Re: Preliminary/Final Subdivision & Land Development - Paradise Village
Phoenixville Borough - SD-02-23-17569 & LD-02-23-17570

A Preliminary/Final Subdivision & Land Development Plan entitled "Paradise Village", prepared by Bercek & Associates, and dated February 15, 2023, was received by this office on February 24, 2023. This plan is reviewed by the Chester County Planning Commission in accord with the provisions of Section 502 of the Pennsylvania Municipalities Planning Code. We offer the following comments on the proposed Subdivision and Land Development for your consideration.

Detail of Sheet 5 of the plan

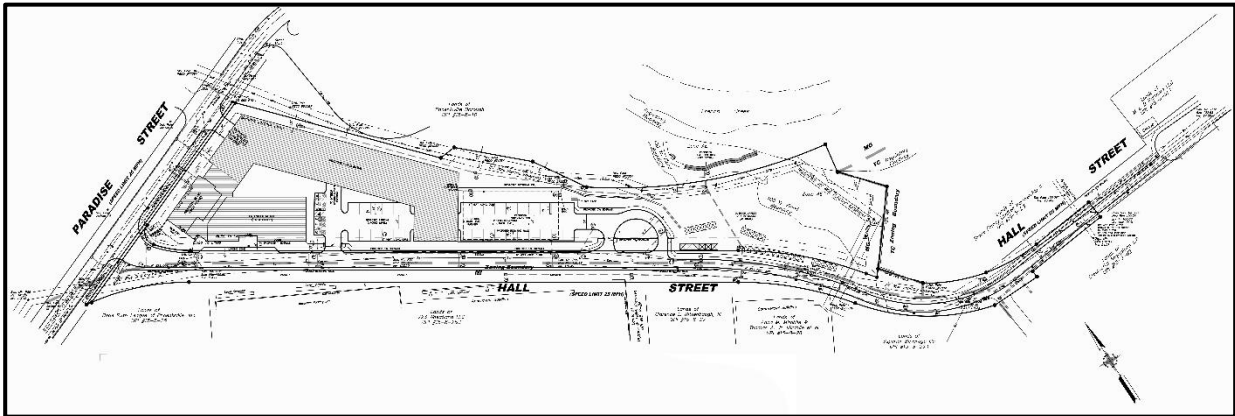
4. Sheet 3 of the plan and aerial photography indicates that the site consists of steep slopes that are almost entirely wooded with areas within the 100 year flood boundary at the eastern end of the site. A 20 foot-wide electric easement crosses the site at the eastern end and follows the northern property line to Paradise Street. The Borough should verify that the proposal is consistent with all steep slope and tree protection standards or that the applicant has received variances or waivers from such provisions. Details of any relief from ordinance provisions should be included in the plan notes.

7. We note that Hall Street reduces width from 22 feet to 12 feet after the east vehicle access to the site and that one-way traffic will be accommodated in an easterly direction. The Borough should consider how a full-width road could be constructed at some future time without disturbance of the newly installed infrastructure. The turnaround at the east end of the site should be designed to accommodate larger vehicles that may need a U-turn option on Hall Street. Also, the Borough should consider how to discourage drivers from going the wrong way on the one-way section of Hall Street.

8. Because of the slopes found on this site the overall design includes several retaining walls. The Borough should verify that the design and specifications of these retaining walls is consistent with all Borough Engineering standards.
